MILLSTONE NUCLEAR POWER STATION, UNIT NO. 2

AMENDMENT TO FACILITY OPERATING LICENSE

Amendment No. 55
License No. DPR-65

ATTACHMENT TO LICENSE AMENDMENT NO. 55

Figure 3.2-1 Allowable Peak Linear Heat Rate vs Burnup

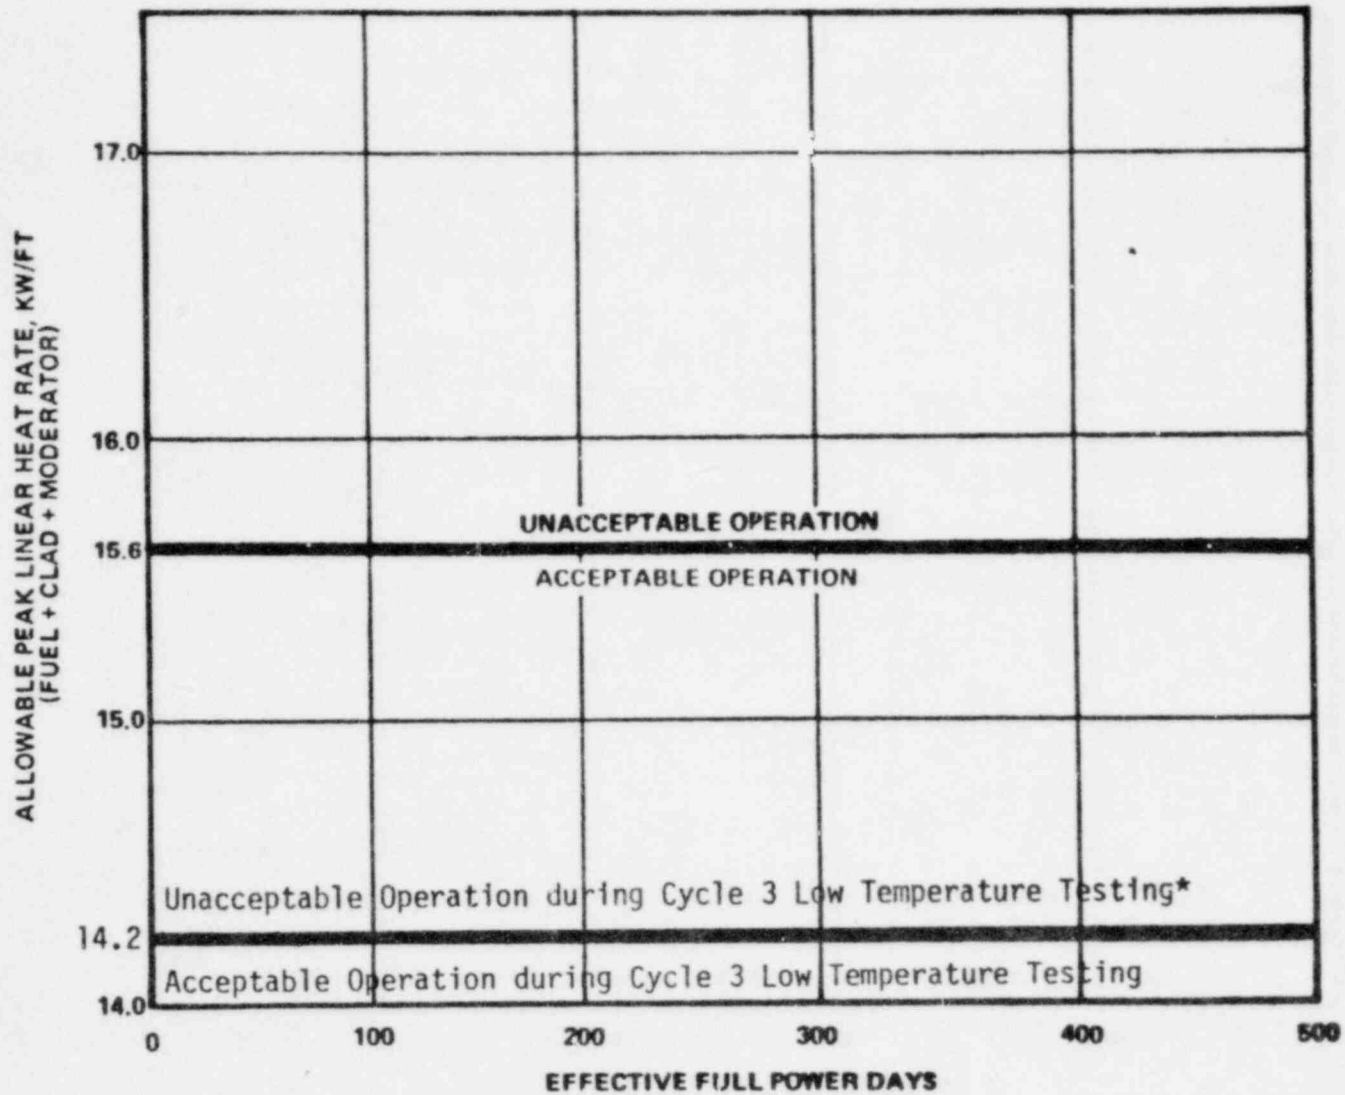
Replace the following page of the Appendix "A" Technical Specifications with the enclosed page. The revised page is identified by Amendment number and contains vertical lines indicating the area of change. The corresponding overleaf page is also provided to maintain document completeness.

*During Cycle 3, low temperature testing is authorized for periods not exceeding 24 hours with the inlet temperature greater than or equal to 537°F and without varying the programmed pressurizer level.
